**HISTORIC PRESERVATION BOARD
CITY OF PORTLAND, MAINE**

**PUBLIC HEARING
522 CONGRESS STREET, 51 OAK STREET, 11 and 15 SHEPLEY STREET**

TO: Chair Romano and Members of the Historic Preservation Board
FROM: Deborah Andrews, Historic Preservation Program Manager
DATE: April 23, 2013
RE: May 1, 2013

Application For: Certificate of Appropriateness for Replacement Signage on Existing Marquee, Installation of New Banners/Projecting Sign
Address: 522 Congress (replacement signage)
51 Oak (banner or projecting sign) 11 & 15 Shepley (banners)
Applicant: Maine College of Art
Represented by: Raffi Der Simonian, Director of Marketing & Communications

New logo Implementation & Proposed Signage Treatment

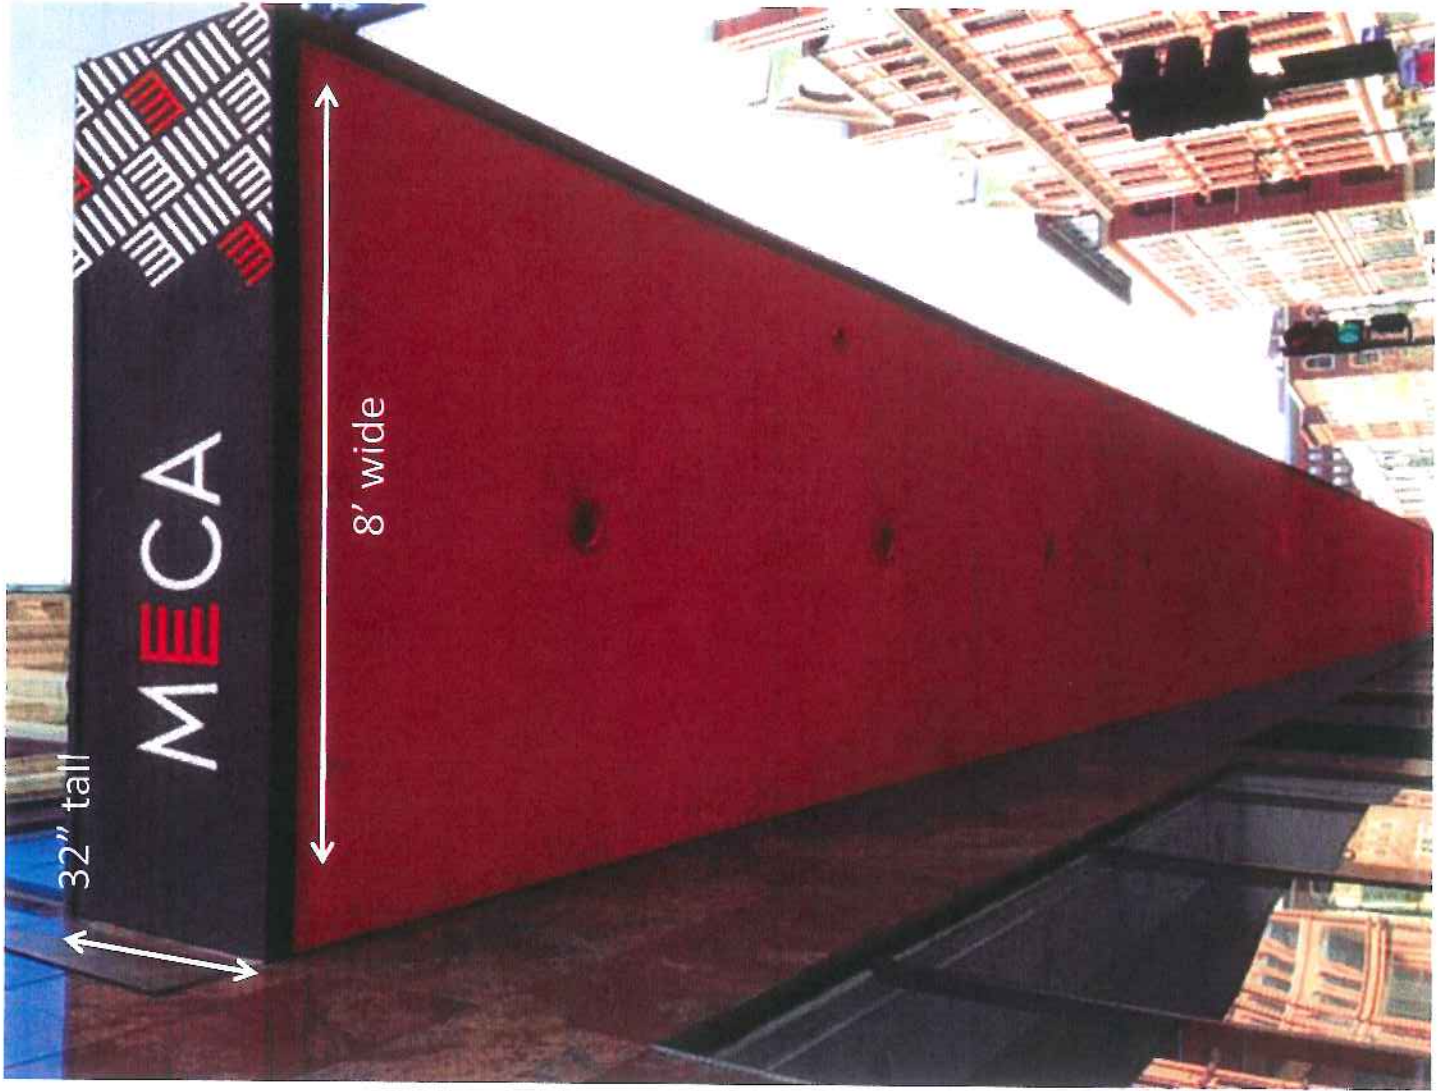
Porteous Building. The proposal calls for installing new graphics and MECA logo at the far sides and ends of the existing 56' wide x 32" tall metal canopy, as well as new applied letters to the center of the canopy. (Although the images show the graphics to scale, no specific dimensions are provided.) Above the canopy, individual metal letters are proposed to be mounted to the 2" leading lip of the canopy. The proposed letters will be 4' tall and 2.25" thick.

Note that the front face of the marquee currently features two wide strips of vents or shallow louvres. Given the presence of the louvres, the graphics at the corners must terminate a considerable distance from the center sign.

**RVCL Series
Adjustable Bracket**

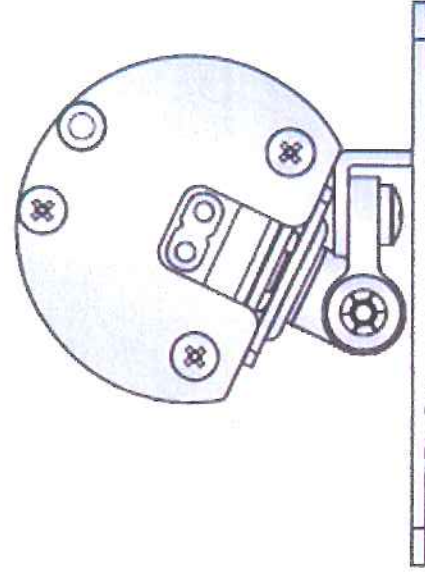
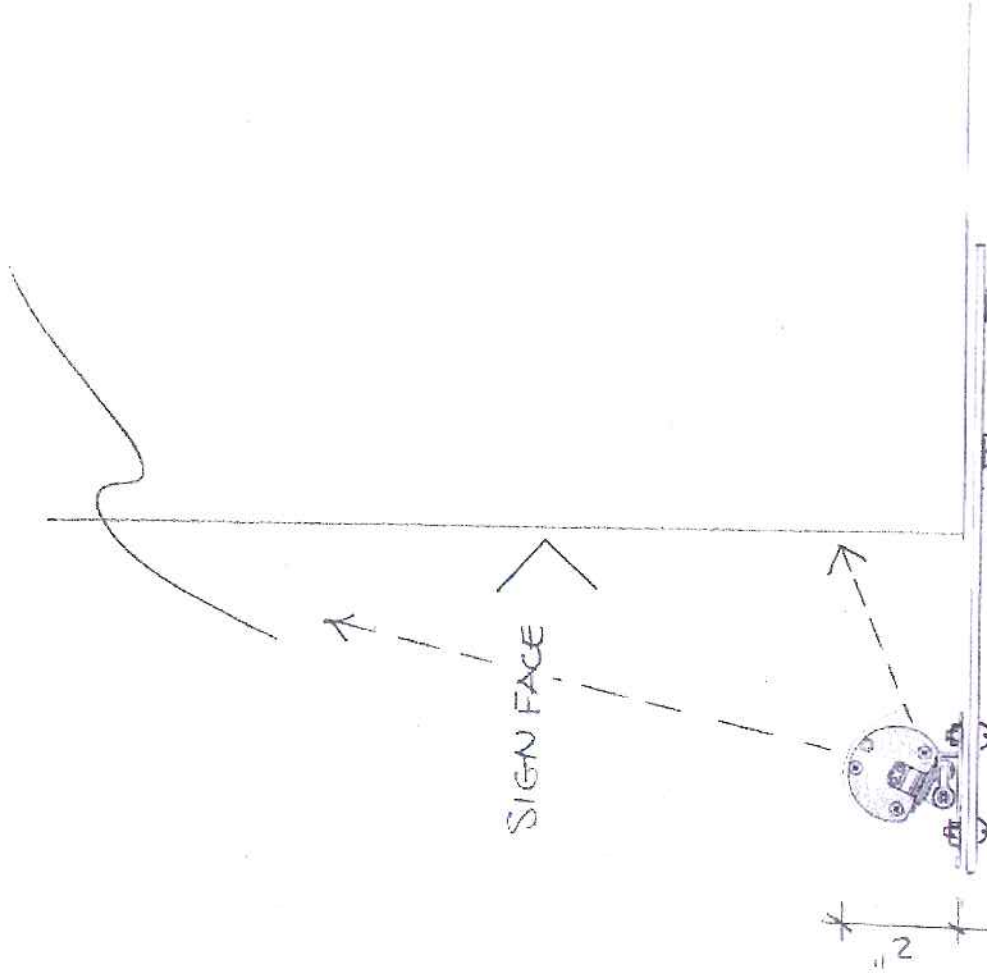
As proposed, LED lighting strips will be mounted to the underside of the canopy at the center and the ends to illuminate the signage areas. A detail has been provided of the fixture and mounted bracket.
